Docket Number:	15-AFC-01
Project Title:	Puente Power Project
TN #:	207118
Document Title:	Response to Comments - To City of Oxnard for time Schedule Order
Description:	Response to Comments for Tentative Time Schedule Order (TSO) for the NRG California South LP Mandalay Generating Station, Oxnard, CA (NPDES No. CA0001180, CI No. 2093). Other related documents: Notice of Public Hearing, Comments from City of Oxnard, and Final TSO. 12/21/15
Filer:	Cathy Hickman
Organization:	Los Angeles Regional Water Quality Control Board
Submitter Role:	Public Agency
Submission Date:	12/24/2015 9:40:30 AM
Docketed Date:	12/24/2015

RESPONSE TO COMMENTS FOR THE TENTATIVE TIME SCHEDULE ORDER (TSO) FOR NRG CALIFORNIA SOUTH LP MANDALAY GENERATING STATION, OXNARD, CA. (NPDES NO. CA0001180, CI NO. 2093).

RESPONSE TO COMMENTS ON THE TENTATIVE TIME SCHEDULE ORDER
NRG California South, LP
Mandalay Generating Station
NPDES Permit No. CA0001180

Attachments: Aerial photo of MGS beach discharge
Photo of condition of discharge facility
Two Photos of public access to MGS beach discharge

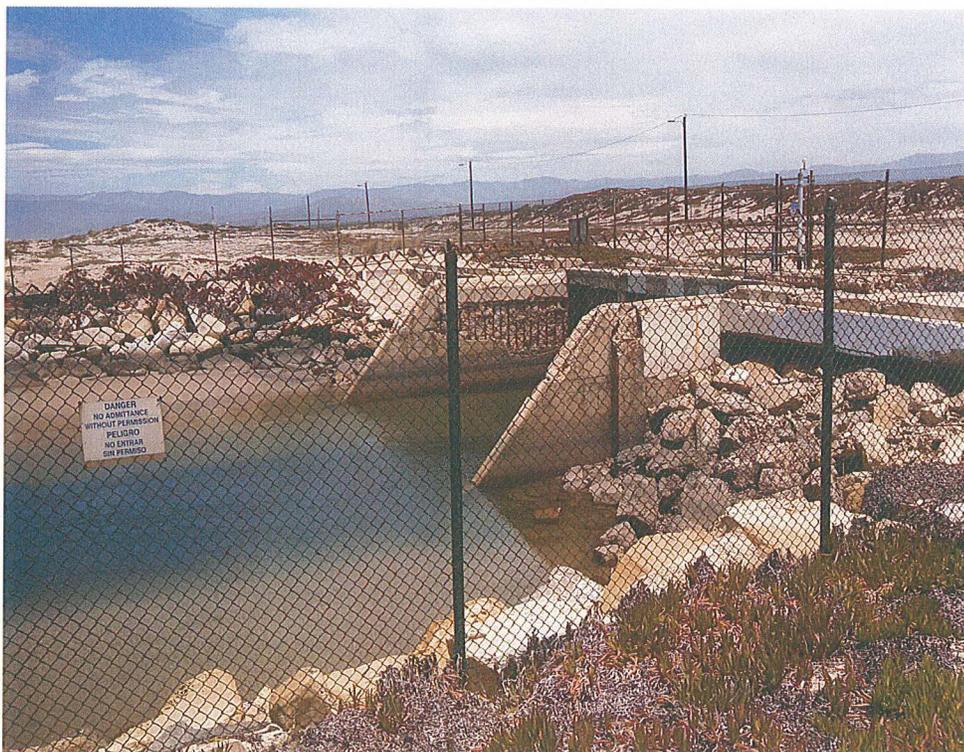
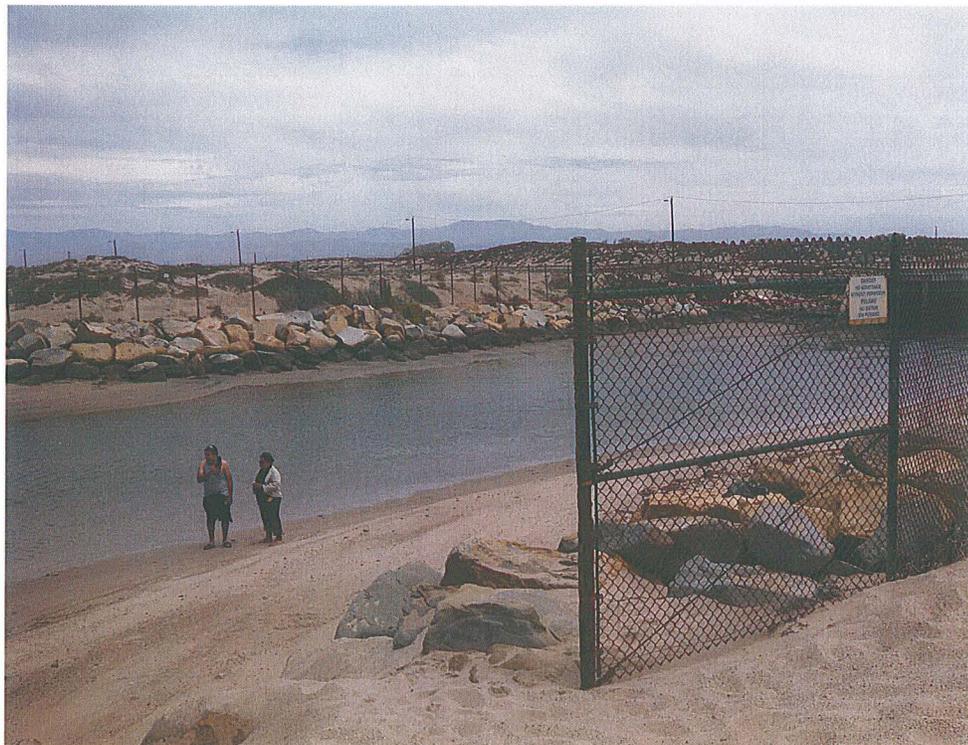
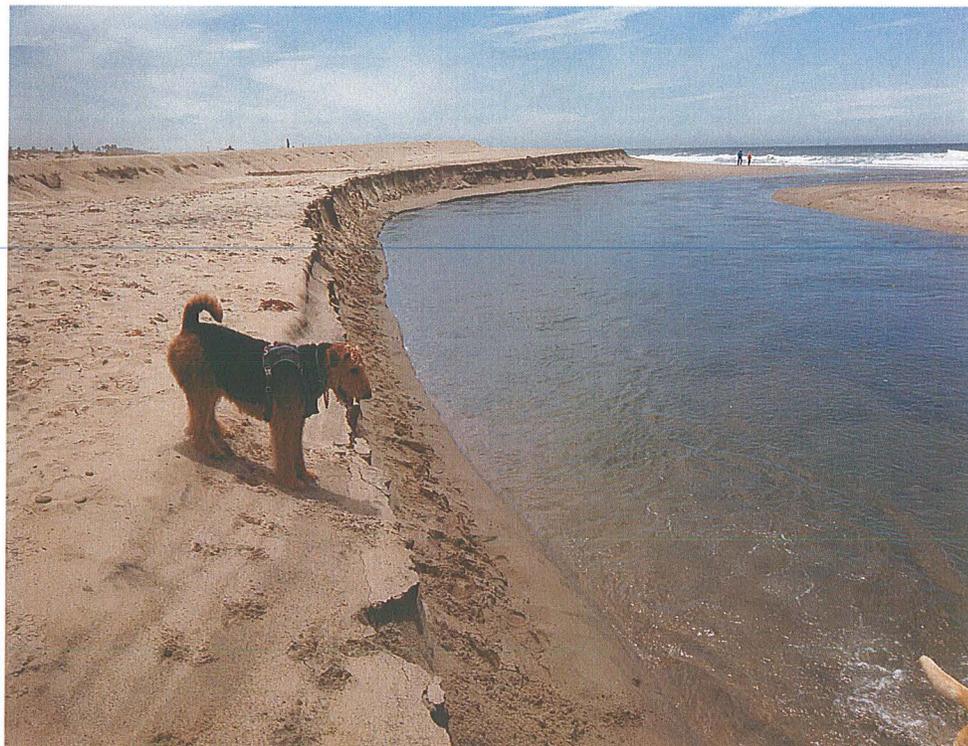
Finally, the beach over which the discharge water travels is a public beach. The discharge, moving at a visible current when the MGS is fully operating, presents an attractive nuisance and safety hazard to the public and inhibits horizontal coastal access in possible violation of the Coastal Act. Photographs are included that show the discharge ponding, condition of the structure, and people and pets wading in the discharge. The proposed P3 facility application indicates NRG will continue to use the beach outfall discharge even though the greatly reduced amount of discharge (NRG's CEC application states total sanitary and wastewater discharge at 19 AFY) could be redirected either to the adjoining Edison Canal or into the City's sanitary sewer system, assuming appropriate water quality requirements and permits are obtained. Discharge into the Edison Canal may actually benefit the canal's water quality by introducing in-flow at what could otherwise be a stagnant 'dead end' that is 1.7 miles from the Channel Islands harbor.

The City requests that the LARWQCB add a condition on the TSO that Discharge Point 001 be discontinued and demolished when the MGS ceases operation and is decommissioned after December 31, 2020 when the MGS must comply with the Once-Through-Cooling policy. NRG has already indicated in the AFC application that the MGS will be decommissioned.

Commenter	No.	Comment	Response
		<p>bulldozers to break through naturally-occurring beach sand berms so that the MGS discharge does not pond and back up into the outflow structure.</p> <p>Finally, the beach over which the discharge water travels is a public beach. The discharge, moving at a visible current when the MGS is fully operating, presents an attractive nuisance and safety hazard to the public and inhibits horizontal coastal access in possible violation of the Coastal Act. Photographs are included that show the discharge ponding, condition of the structure, and people and pets wading in the discharge. The proposed P3 facility application indicates NRG will continue to use the beach outfall discharge even though the greatly reduced amount of discharge (NRG's CEC application states total sanitary and wastewater discharge at 19 AFY) could be redirected either to the adjoining Edison Canal or into the City's sanitary sewer system, assuming appropriate water quality requirements and permits are obtained. Discharge into the Edison Canal may actually benefit the canal's water quality by introducing in-flow at what could otherwise be a stagnant "dead end" that is 1.7 miles from the Channel Islands harbor.</p> <p>The City requests that the Regional Water Board add a condition on the TSO that Discharge Point 001 be discontinued and demolished when MGS must comply with the Once-Through-Cooling policy. NRG has already indicated in the AFC application that the MGS will be decommissioned.</p>
